Binghamton-Johnson City
FINAL
JOINT SEWAGE BOARD
MINUTES OF SPECIAL BOARD MEETING
OF THE BINGHAMTON - JOHNSON CITY
JOINT SEWAGE BOARD

Monday, July 29, 2013
Construction Trailer

DOCUMENT A1.0

**SUPPLEMENTARY NOTES TO
MODULAR BUILDING SCHEMATIC/CONCEPTUAL FLOOR PLAN**

FIGURE 1 - NOT TO SCALE
BINGHAMTON-JOHNSON CITY JOINT
SEWAGE TREATMENT PLANT

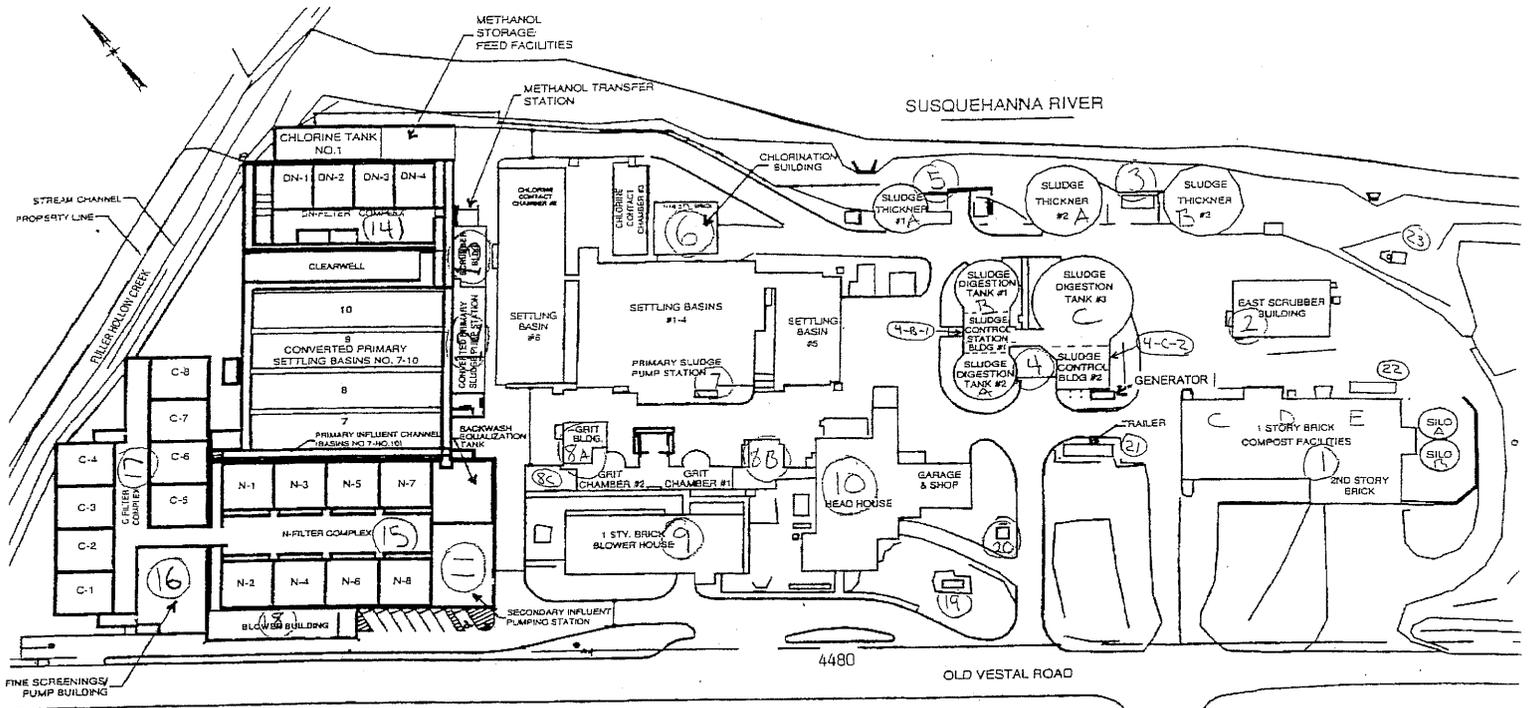
1. a. Where will the staging area be?

A: The staging area is on the driveway in front of the Compost Facility. Please see the light blue rectangle overlaid on the attached Site Diagram (please also note that there is no through traffic).
